GO BUILT
Hall
6-28-10

PROJECT MOUNT PLEASANT ELEMENTARY SCHOOL 2009 RENOVATIONS & ADDITIONS
ROANOKE COUNTY PUBLIC SCHOOLS
3216 MOUNT PLEASANT BOULEVARD
ROANOKE, VA
DRAWING OFFSITE WATERLINE (ALTERNATE)
VIRGINIA DEPARTMENT OF EDUCATION, 80-58D

GNI JN	2055.0
SHEET	
C4-02

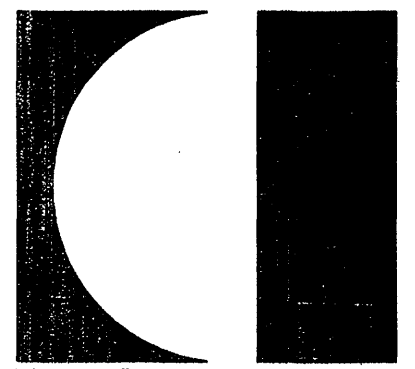
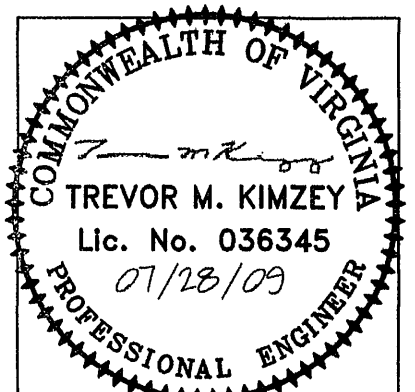
840' OF 8"

2 ea 45° bends
1-Hor.
1-vert.

- Jae Valley rd crossing
is inside 18" steel
casing with spiders.
- Additional 45° vertical
bend was used to avoid
conflict with gas line &
storm sewer
